***Urgent Field Safety Notice for:
Dako Autostainer Instruments (AS480; AS100; S3800; S3400):***

Update of Autostainer Link Basic User Guide to reduce risks of staining issues due to leakage

“Instrument leakage inspection

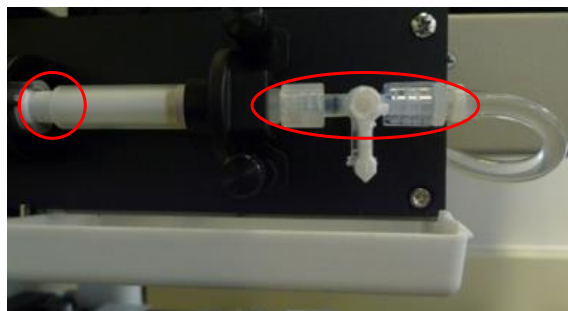
- **New section below has been added regarding inspecting the instrument for signs of leakage** (Table in “Cleaning and Maintenance Guideline Summary”, in English version: page 182, and in subsection “Instrument Leakage Inspection”, start of subsection in English version: page 188)

Visually Inspect the left plate, and the area around the wash station for salt residues and/or liquid, see pictures below. If there are signs of unexpected salt residues and/or liquid, contact your local Agilent Technical Service representative as this might indicate a leakage in the liquid system. If leakage is observed, the slides from the run just completed must be closely reviewed for staining abnormalities.”

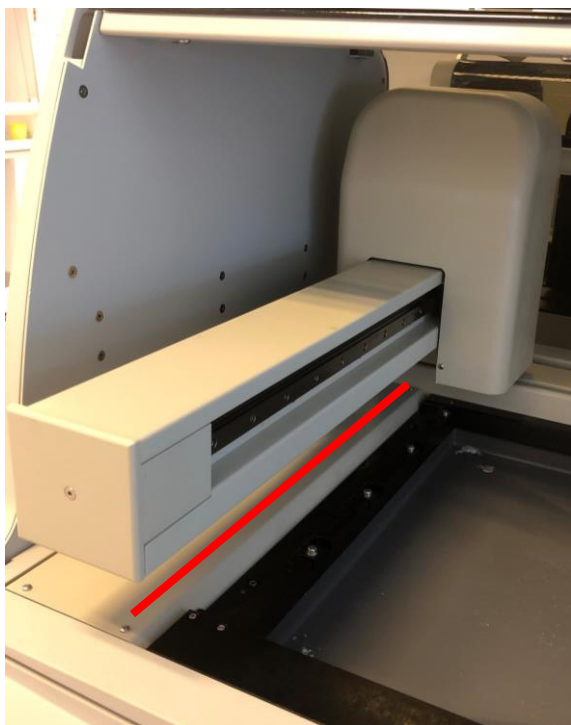
WARNING Leakage from the robotic arm or z-head may impact staining quality. Do not use the instrument if there are signs of unexpected leakage (salt residues and/or liquid), or if you observe leakage.

Visually inspect the syringe tray, syringe and stopcock, areas highlighted in red, for signs of unexpected leakage (salt residues and/or liquid).

Visually inspect the left plate, area highlighted in red, for signs of unexpected leakage (salt residues and/or liquid). This might indicate leakage from the robotic arm.

Visually inspect the area around the wash station, area highlighted in red, for signs of unexpected leakage (salt residues and/or liquid). This might indicate leakage from the z-head or too high pump pressure.
